▼ about AC Adapter

Symptoms of repeated negotiations without load

Enlarged waveform

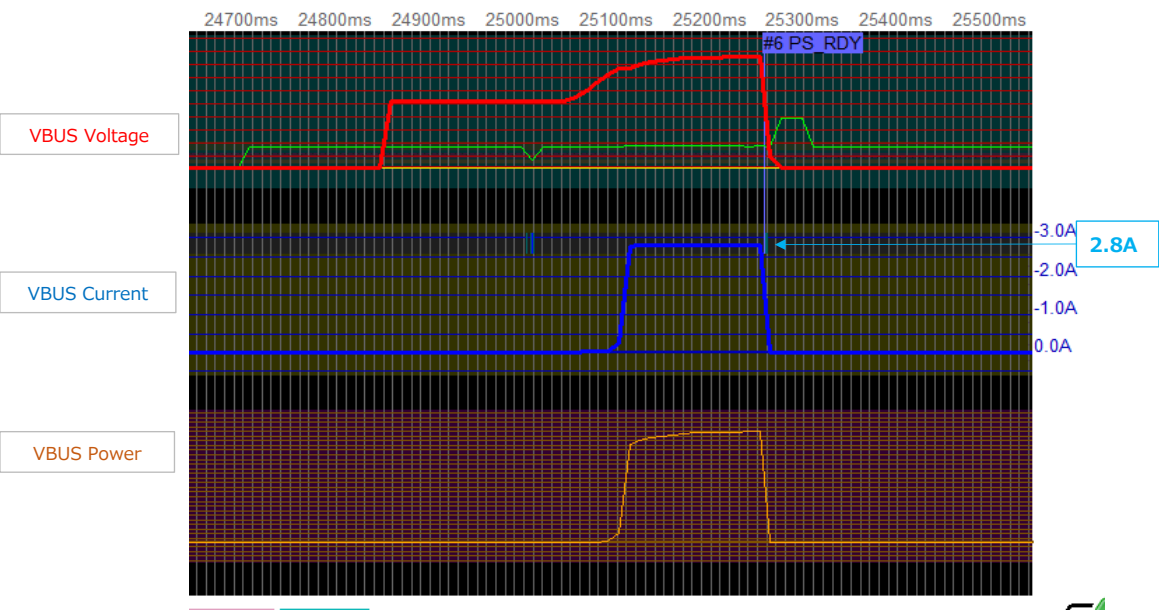
- TPS25750 sinks current before the source device sends "PS_RDY".
- It recognized 9V/2A, but TPS25750 sinks 2.8A.

TPS25750 should sink current after the negotiation value is written in the BQ25792 register IINDPM.

▼Logs with protocol analyzer

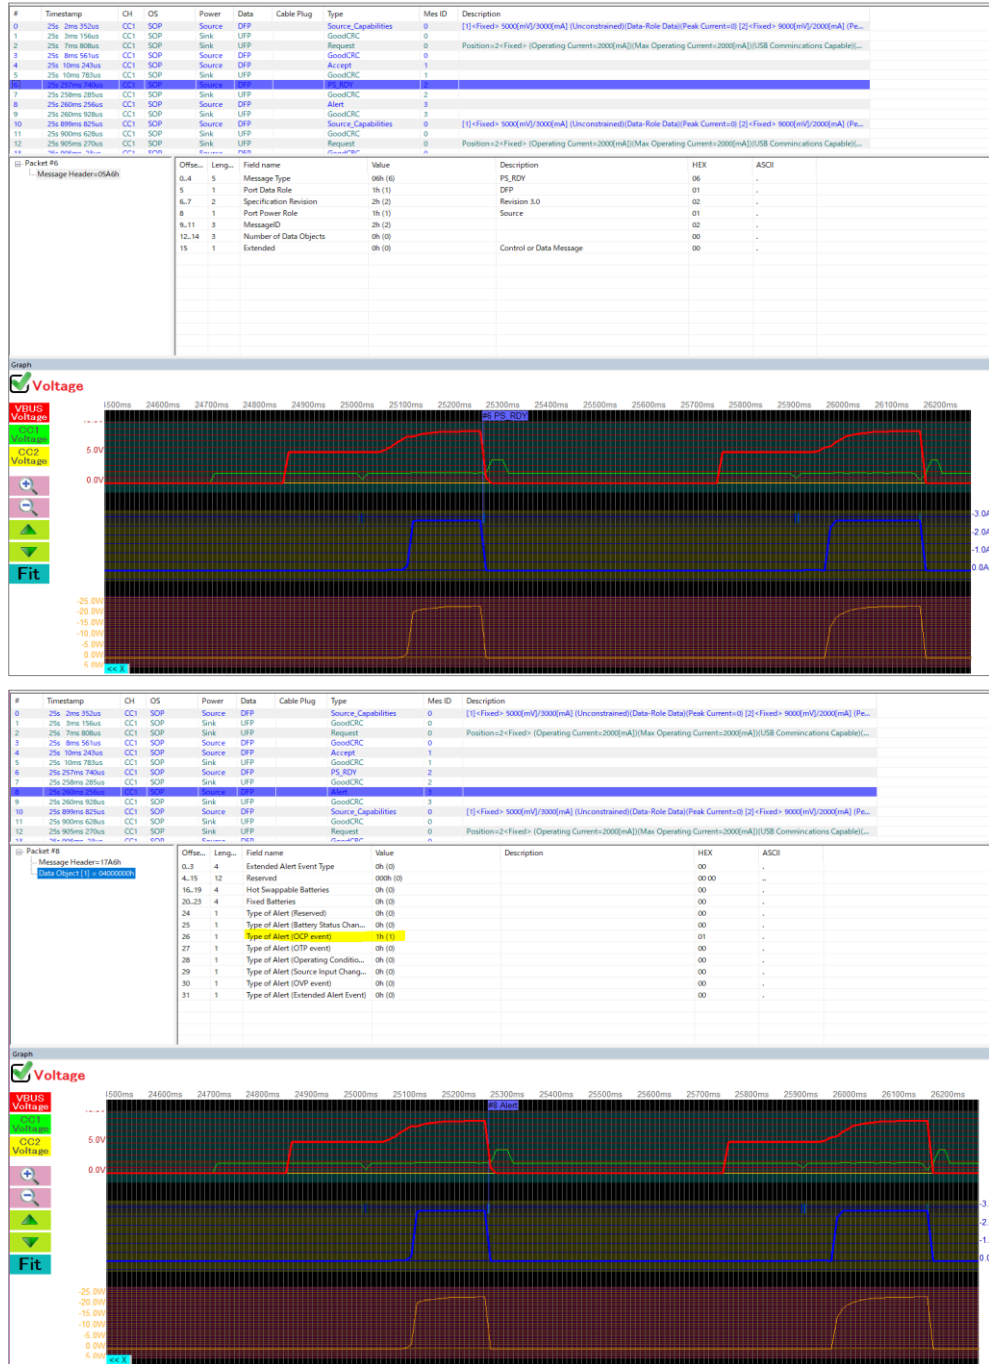
According to "7.3.1.1.2.2 Increasing the Voltage and Current" on page 305 of Universal Serial Bus Power Delivery Specification "USB_PD_R3.1 V1.0 2023-04.pdf", SOURCE device must change the VBUS voltage and make it stable before sending PS_RDY. If confirming the logs, an OCP (Over Current Protect) has been issued by SOURCE device. Additionally, the SINK device must sink current after PS_RDY is sent from the SOURCE device. Please see the USB PD specification.

1 Immediately after connection

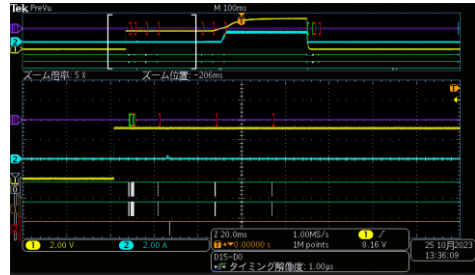
Reg	W or R	Data1	Data2	Reg
REG16_Temperature_Control Register	Write	C0		
REG01_Charge_Voltage_Limit Register	Write	06	90	
REG03_Charge_Current_Limit Register	Write	00	A0	
REG0A_Re-charge_Control Register	Write	EF		
REG17_NTC_Control_0 Register	Write	02		
REG06_Input_Current_Limit Register	Write	01	2C	IINDPM_8:0 =3000mA
REG05_Input_Voltage_Limit Register	Write	2E		VINDPM_7:0=4600mV
REG13_Charger_Control_4 Register	Read	11	1C	
REG13_Charger_Control_4 Register	Write	01		
REG1C_Charger_Status_1 Register	Read	10		
REG13_Charger_Control_4 Register	Read	01	1C

2 When increasing VBUS voltage and current

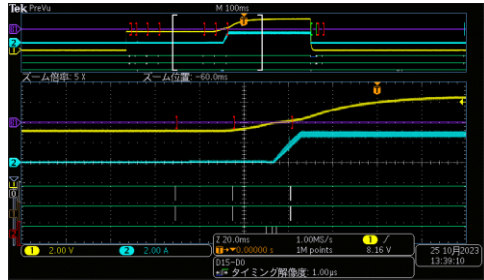
Reg	W or R	Data1	Data2	Reg
REG13_Charger_Control_4 Register	Write	C0		
REG01_Charge_Voltage_Limit Register	Write	1C		
REG13_Charger_Control_4 Register	Write	11		
REG1C_Charger_Status_1 Register	Read	70

3 After VBUS voltage decreases

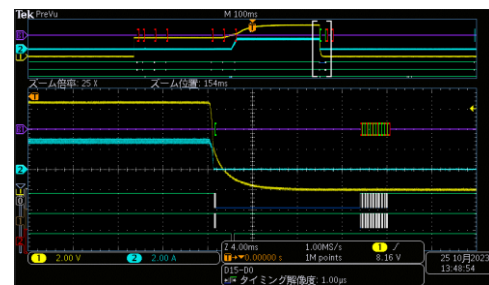
Reg	W or R	Data1	Data2	Reg
REG06_Input_Current_Limit Register	Write	C8		IINDPM_8:0 =2000mA
REG10_Charger_Control_1 Register	Write	80		
REG14_Charger_Control_5 Register	Write	1C		
REG11_Charger_Control_2 Register	Write	00		
REG12_Charger_Control_3 Register	Write	00		
REG08_Precharge_Control Register	Write	C8		
REG09_Termination_Control Register	Write	05		ITERM=5h=200mA
REG00_Minimal_System_Voltage Register	Write	06	90	
REG03_Charge_Current_Limit Register	Write	00	A0	ICHG=1600mA
REG0A_Re-charge_Control Register	Write	EF		VRECHG=800mV
REG17_NTC_Control_0 Register	Write	02		JEITA_1SETC_1:0=20%
